DOCKET NO.: 980946-TL: Petitions for temporary waiver of physical collocation requirements set forth in the 1996 Telecommunications Act and the FCC's First Report and Order, for the Daytona Beach Port Orange Central Office, by BellSouth Telecommunications, Inc.

INVESTIGATION OF COLLOCATION SPACE WAIVERS

DAYTONA PORT ORANGE OFFICE

**DOCKET NO. 980946-TL
AUDIT CONTROL NO. 98-334-4-1**

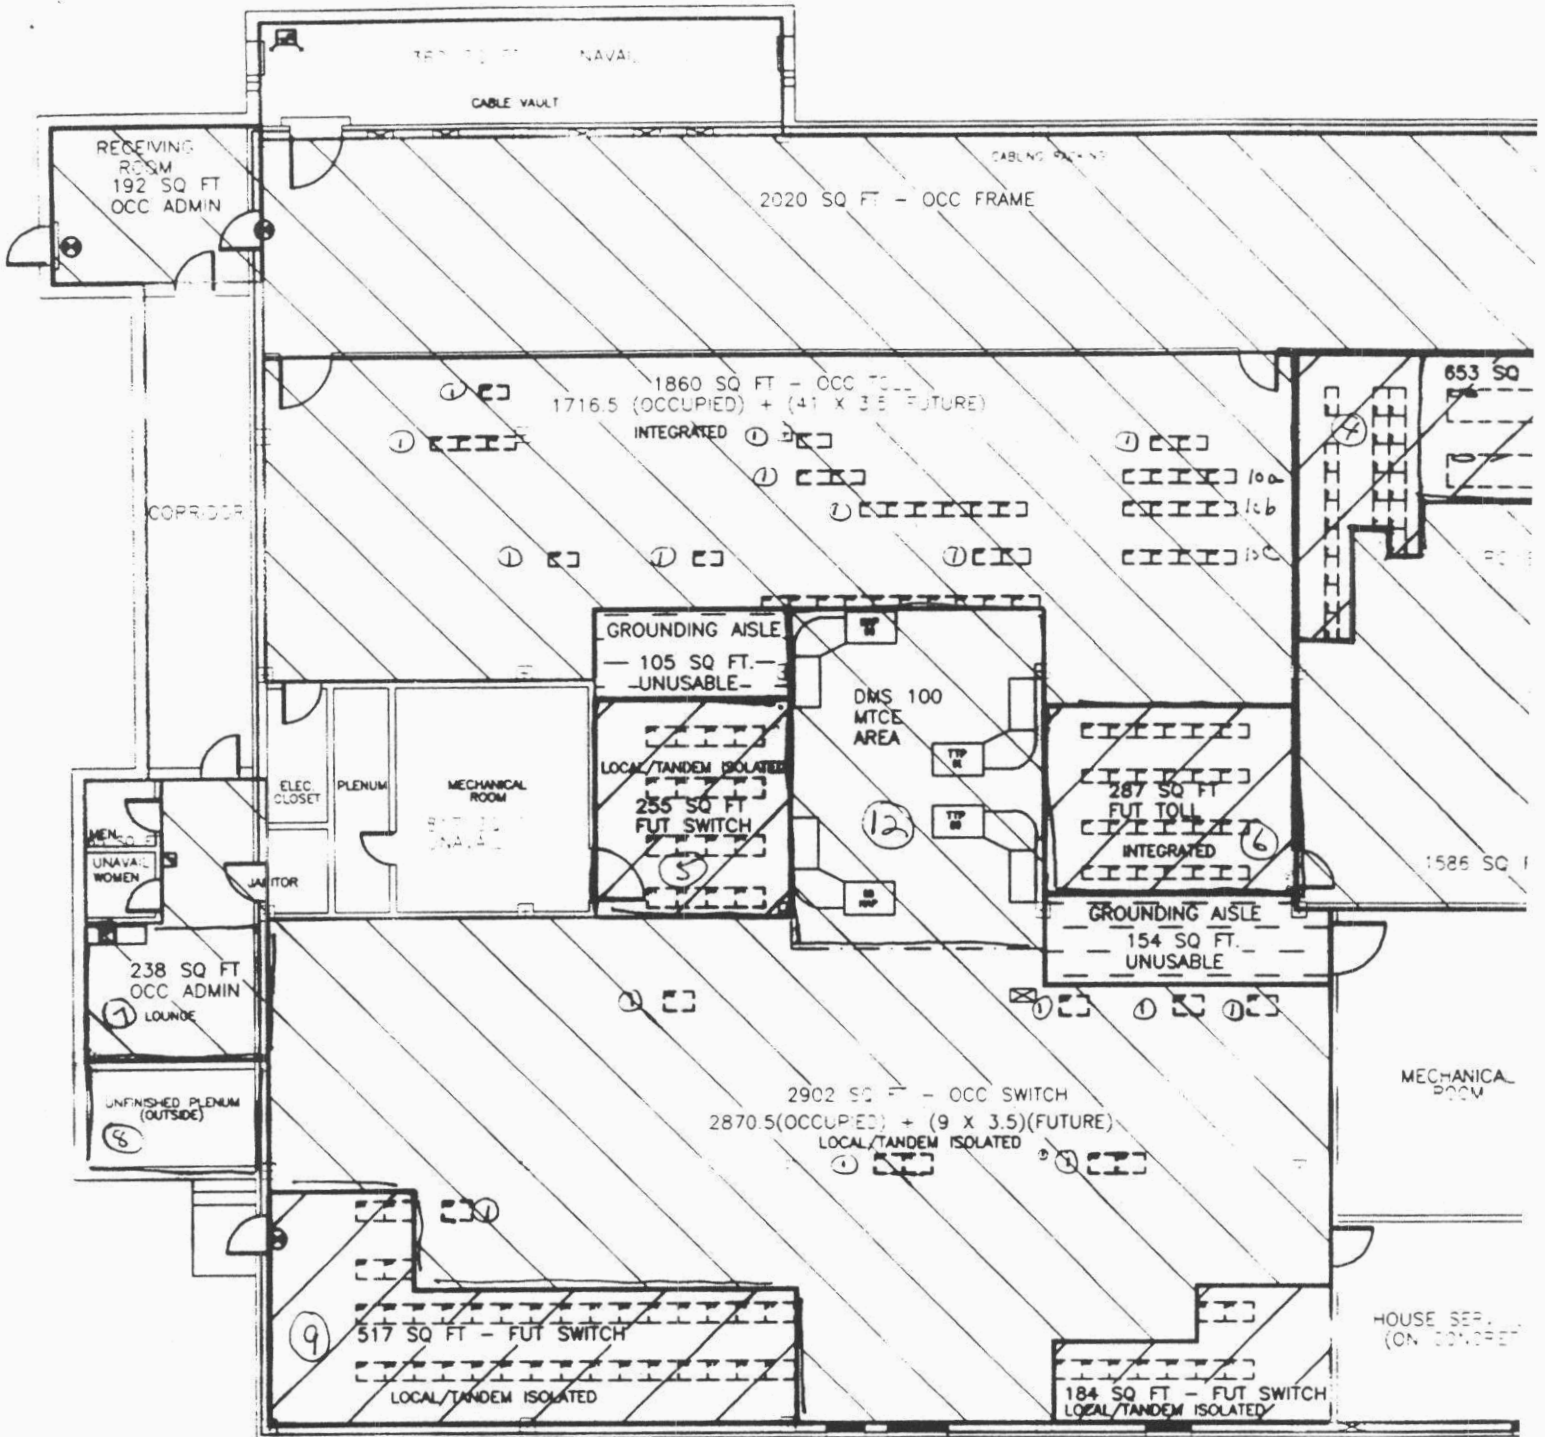
OPINION: Area 2 is 22' 5" by 9'6" or approximately 213 square feet. After the fire wall is installed the space would be 18'5" by 4'6". This would not allow for space on either side of a lineup for a fire aisle or room to work.

Area 3 is 19'3" by 11' or approximately 212 square feet. This does not have access to an outside wall, requires fire rated walls and 4' fire aisles next to BellSouth equipment. Removing 4' for a fire aisle and a foot for a wall leaves an area 6' wide. It is necessary to find out if a six foot wide area would hold one line up of bays with room to work in

Area 11 is less than the 100 square feet offered as a minimum by BellSouth (See Disclosure 5) to a collocater. Adding in fire aisles would make this a minimal space.

33850 DAYTONA BEACH - PORT ORANGE FIRST

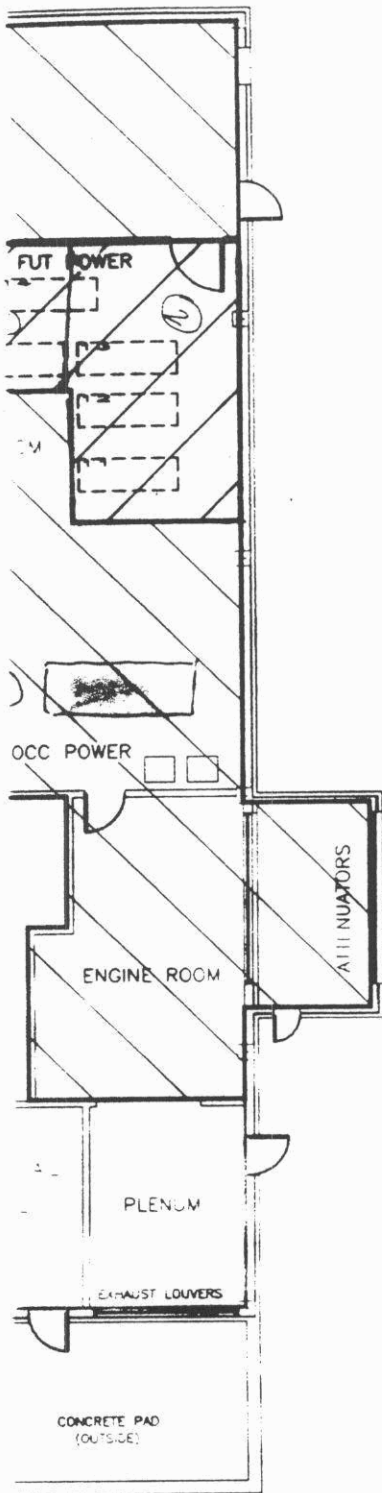
Area 5 is 13' by 22' or approximately 286 square feet and is designated for future switch equipment. The company says that because of grounding, a seven foot aisle is needed between existing switch equipment, leaving usable space of 187 square feet. There are no forecasts or jobs for the footprints in the map. The company says that is reserved for future switching equipment, and is on isolated ground plane.

Area 6 is 16' by 21' or approximately 352 square feet for future toll equipment. The company says that because of grounding, a seven foot aisle is needed between existing switch equipment, leaving usable space of 189 square feet. This space is reserved for future circuit (toll) growth, but at present there are no jobs in process and no forecasts. This area is on an integrated ground plane. The information provided by the company shows that the toll equipment bays in this office grows about five to six a year. There are more than 12 bays open in the toll area at this time. See items marked 1 and 10 in toll area on map and Audit Disclosures 10 and 11.

OPINION: In order to use areas 5 and 6 for collocation, one area would have to be used for the collocator, one area for the common area, and some connection made. The space does not have to be contiguous. (See Disclosure 5). There are air ducts, and cable racks above the spaces which the company says would cause a problem in building fire rated walls to the ceiling. Area 5 is an isolated grounding plane (See Disclosure 1). If able to obtain a permit, a caged area in area 6 may be possible since this is an integrated ground plane.

Common Area
Palmetto C.O.

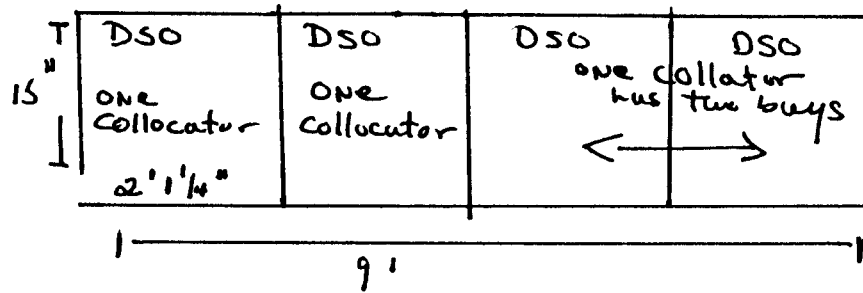
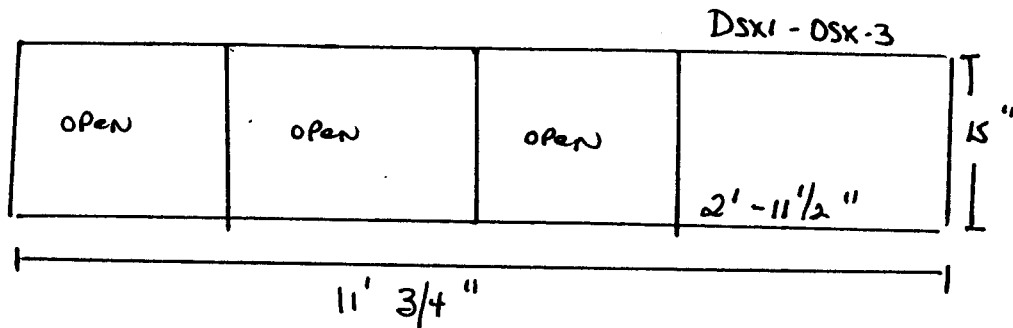
The BellSouth common area for collocation is area 16 on the map and measures 20'2" by 9'2" which is approximately 183 square feet. A drawing of the common area is attached. This drawing is not to scale.

The second line up has four bays, only one bay is filled with DSX1 and DSX3 termination equipment. The rest are empty. The company says the capacity of this bay is five shelves of DSX1 and DSX3 equipment. Right now there are three shelves with terminations which leaves two shelves on this bay. The dimensions of these DSX3 bays are 2' 11-1/2" wide with a depth of 15 inches. The length of the present four bays is 11 and 3/4 feet. This leaves approximately nine feet to continue the line up. The company says it could add three DSX1-DSX-3 bays or four DSO bays to this line up.

The collocator who has 200 square feet has 14 bays. The collocator who has 100 square feet has 6 bays. We asked the collocator who has six bays how many years growth it had. The collocator responded that "... it expected to populate all six bays in the Palmetto office within two years." The collocator with 200 square feet did not respond to our request.

Company Says
Room to add
only 2 DSO Bays
because of door

Company Says
Room to add
3 DSX-1-DSX-3 bays size
or 4 DSO bay's size

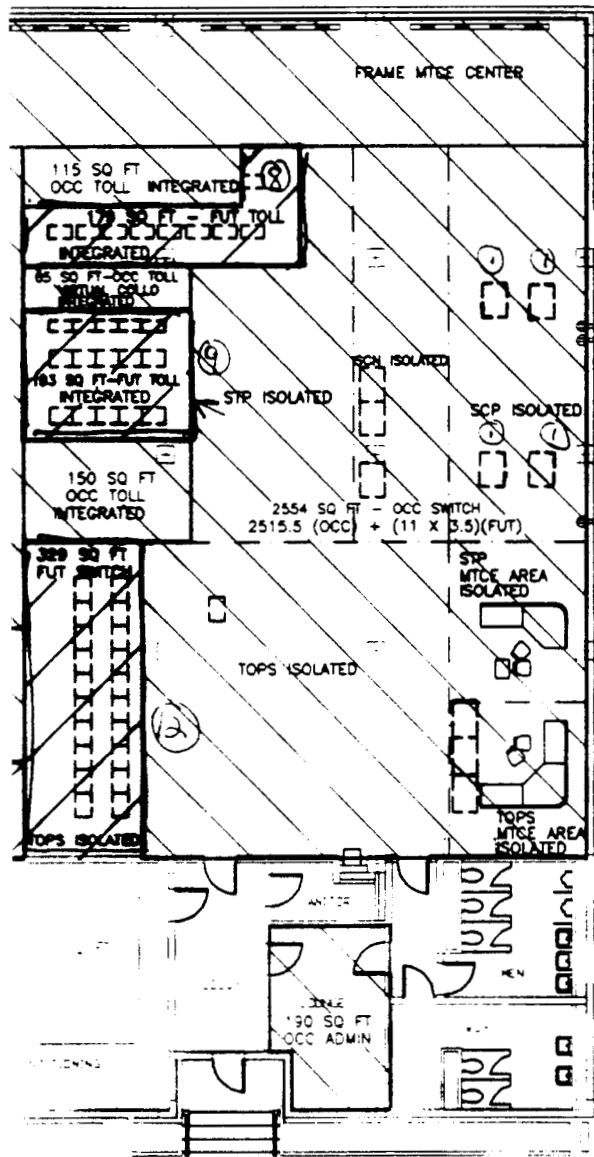
STATEMENT OF FACT: Areas 10 and 10a are part of the shipping and receiving room and no equipment is planned for this area. The entire shipping and receiving room is 20'4" by 21'. It has an entrance to the building from the outside and another door to the inside of the central office. The company stated that this room has fire rated walls. However, this is the only place in the office to bring in equipment. The width of the door is 48'. This is good for delivery. The second door into the office goes to the ceiling.

Area 2 is the new equipment staging area. There are two footprints for future local switch growth. One line up is planned for 2000 and the second line up is for 2002 and 2003. This is in the switch area which is on an isolated ground area. (See Disclosure 1 for discussion on isolated and integrated ground planes.) The dimensions of the area without the 2000 forecast are 24' by 6'5".

Area 11 is part of the central office maintenance area. There are three maintenance areas. The one closest to the shipping and receiving room and the one marked off on the map has three terminals. These are a terminal to log in time sheets, a local maintenance terminal and a trunk testing terminal. There are no footprints for future use in this area. When asked if the third maintenance space could be condensed for future growth, the company said it is a possibility (See Audit Disclosure 1, item 7). There are no footprints for future growth in this area.

ground plane restrictions here. The area left for receiving and uncrating would be about 200 square feet. The company might be able to use area 2 for its uncrating and setting up of equipment since it is not all planned for growth through 2001. The company's response to the use of this area is that "...using any part of the room for another tenant requires construction of a new BST exit or a fire rated corridor through the middle of the space for BST exit and delivery." BellSouth believes that construction is not required of any incumbent LEC by the FCC (See Disclosure 1, Item 7).

For Area 11, if an area 10' by 10' were carved out of the maintenance area and BellSouth condensed its maintenance work stations, there would still be the problem of the switch equipment which is on an isolated ground plane adjacent to the area. Four foot fire aisle space would take away from the 10 by 10 space. Also the issue of renovating by the incumbent LEC has to be addressed as stated above.
